AGENDA
HAILEY PLANNING & ZONING COMMISSION
Monday, April 19, 2021
Virtual Meeting
5:30 p.m.

STAFF REPORT
Hailey Planning and Zoning Commission
Regular Meeting of April 19, 2021

ANTONY & SARAH GRAY RESIDENCE
HAILEY LOTS 1, 2, 3 & 4, BLK 38, 12,000 S.F.
121 N. 3RD AVE, HAILEY, IDAHO

STAFF REPORT
Hailey Planning and Zoning Commission
April 19, 2021

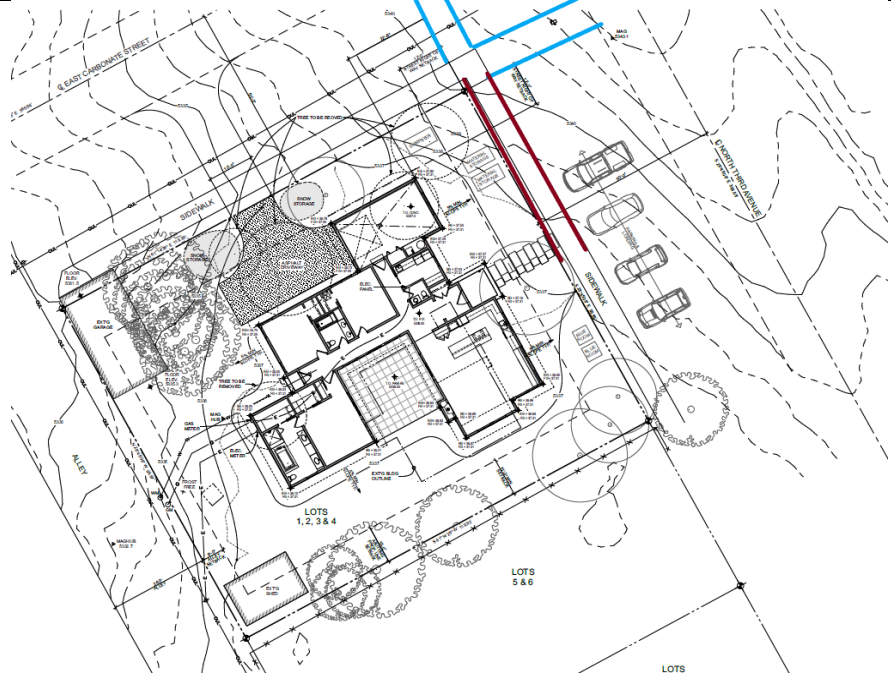
General Requirements for all Design Review Applications				
Compliant			Standards and Staff Comments	
Yes	No	N/A	City Code	City Standards and Staff Comments
<input checked="" type="checkbox"/>	<input type="checkbox"/>	<input type="checkbox"/>	17.06.050	Complete Application
<input checked="" type="checkbox"/>	<input type="checkbox"/>	<input type="checkbox"/>	Department Comments	<p>Engineering, Streets and Public Works: <i>The existing driveway is 30' from the intersection of the two public roads, Third Avenue and Carbonate Street. In the original design, the Applicant proposed that the garage gain access from Third Avenue, where the driveway is approximately 14' from the intersection of these roads. Due to the proximity of the proposed driveway to the intersection, the Commission found that the proposed driveway and garage would impede visibility of vehicular and pedestrian traffic coming from Third Avenue and Carbonate Street. The Commission strongly encouraged the Applicant to position the proposed garage and driveway off of the alley or reconfigure the site in differently, to be reviewed by the Commission at a later date.</i></p> <p><i>The Public Works Department also recommended and the Commission concurred that the sidewalk along Carbonate Street and Third Avenue be extended to the edge of asphalt on both Carbonate Street and Third Avenue (see the blue lines in the image below for further details).</i></p>

With the new configuration, the Applicant is proposing that the garage door face the alley; however, access be achieved from Carbonate Street. The reasons that the Applicant proposes this configuration are 1) to retain all of the historic outbuildings located on the alley side of the property; 2) the garage off of the alley would require a step into the house due to grade change.

Planning Staff feels the current proposal is more aligned with the Design Review Guidelines for Townsite Overlay than the previous proposal for the following reasons:

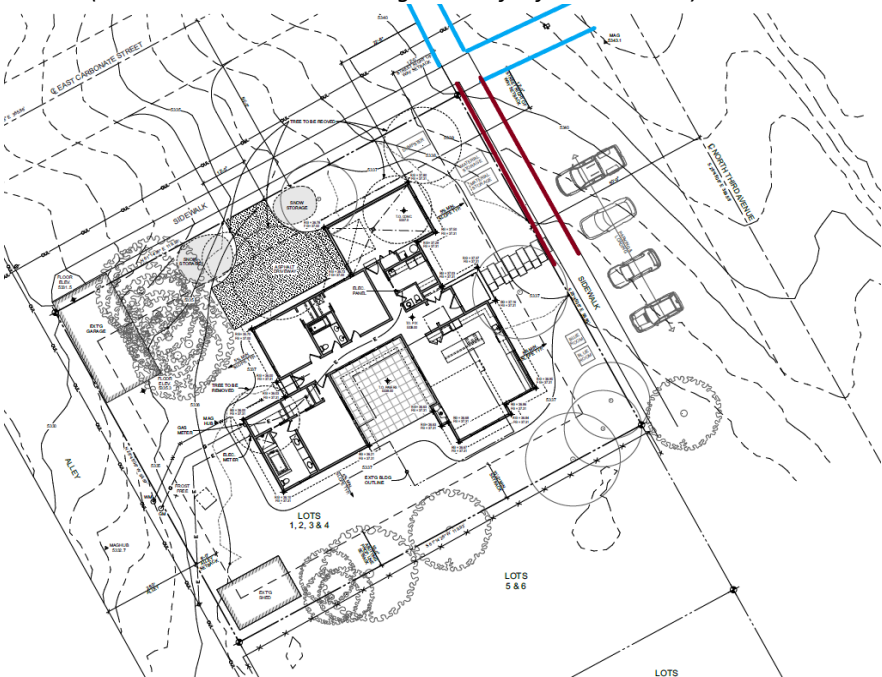
<input checked="" type="checkbox"/>	<input type="checkbox"/>	<input type="checkbox"/>	17.06.070(A)1 Street Improvements Required	<p>Sidewalks and drainage improvements are required in all zoning districts, except as otherwise provided herein.</p>
			Staff Comments	<p><i>Sidewalks are existing along the property frontage of Third Avenue and Carbonate Street. That said, the Public Works Department recommended and the Commission concurred that the sidewalk along Carbonate Street and Third</i></p>

<p><i>Avenue be extended to the edge of asphalt on both Carbonate Street and Third Avenue (see the blue lines in the image below for further details).</i></p>  <p><i>Planning Staff also suggests that the existing driveway, off of Third Avenue, be removed and the area be revegetated, and that the sidewalk along the property frontage and where the previous driveway was, be installed/repaired/replaced (see the red lines in the image above for further details). The existing sidewalks, as outlined by the Public Works Department, prior to issuance of a Certificate of Occupancy.</i></p> <p><i>Furthermore, a detailed engineering plan with grading and drainage shall be provided prior to issuance of a Building Permit. The Public Works Department will need to review the final design before additional recommendations can be made.</i></p> <p><i>Comments above have been made Conditions of Approval. the image below for further details). This has been made a Condition of Approval.</i></p>

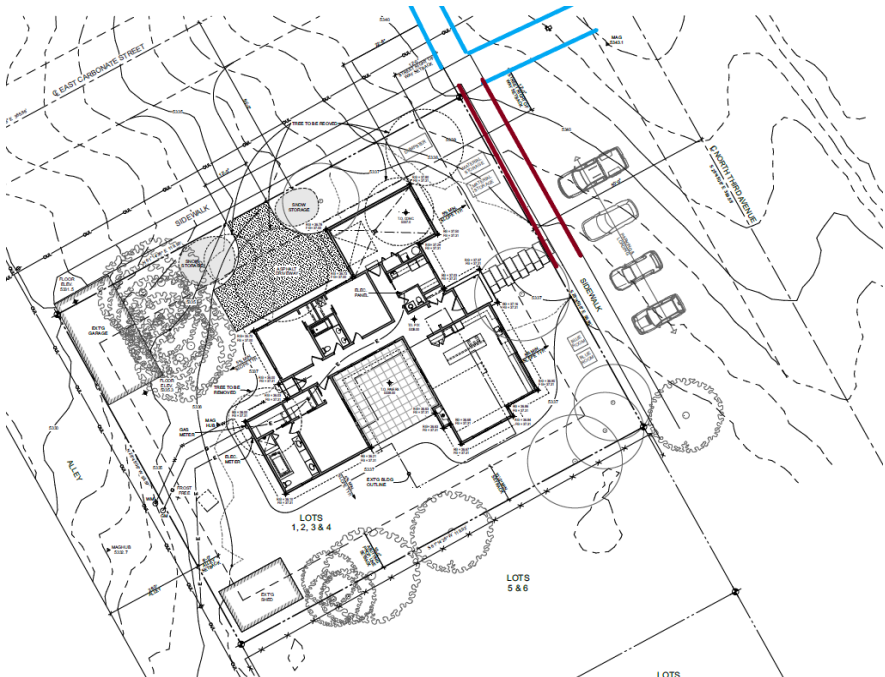
Staff Comments	Please refer to Section 17.06.090(C)3i for further information.
<input type="checkbox"/> ?	<input type="checkbox"/>	<input type="checkbox"/>	17.06.090(C)4	4. Circulation and Parking
				Guideline: Safety for pedestrians shall be given high priority in site planning, particularly with respect to parking, vehicular circulation and snow storage issues.
			Staff Comments	<p>Adequate parking has been provided. The existing driveway is 30' from the intersection of the two public roads, Third Avenue and Carbonate Street. In the original design, the Applicant proposed that the garage gain access from Third Avenue, where the driveway is approximately 14' from the intersection of these roads. Due to the proximity of the proposed driveway to the intersection, the Commission noted that, in addition to being inconsistent with Design Review Guidelines which direct vehicular access to alleys, the proposed driveway and garage would impede visibility of vehicular and pedestrian traffic coming from Third Avenue and Carbonate Street. The Commission strongly encouraged the Applicant to position the proposed garage and driveway off of the alley or reconfigure the site in differently, to be reviewed by the Commission at a later date.</p> <p>The Public Works Department also recommended and the Commission concurred that the sidewalk along Carbonate Street and Third Avenue be extended to the edge of asphalt on both Carbonate Street and Third Avenue (see the blue lines in the image below for further details).</p>  <p>With the new configuration, the Applicant is proposing that the garage door face the alley; however, access be achieved from Carbonate Street. Planning Staff feels this is a more appropriate alternative to the original proposal, but the Commission may wish to discuss further.</p> <p>Planning Staff also suggests that the existing driveway, off of Third Avenue, be removed and the area be revegetated, and that the sidewalk along the property</p>

<p><i>frontage and where the previous driveway was, be installed/repaired/replaced (see the red lines in the image above for further details). The existing sidewalks may also need some repairing. The Applicant shall repair the existing sidewalks, as outlined by the Public Works Department, prior to issuance of a Certificate of Occupancy.</i></p> <p><i>Furthermore, a detailed engineering plan with grading and drainage shall be provided prior to issuance of a Building Permit. The Public Works Department will need to review the final design before additional recommendations can be made.</i></p> <p><i>Comments above have been made Conditions of Approval.</i></p> <p><i>Lastly, pedestrian access is provided with the proposed pathway to the front entry of the residence. Snow storage areas are located to the east and west of the proposed driveway, located off of Third Avenue. Snow storage areas do not appear to restrict pedestrian access.</i></p>
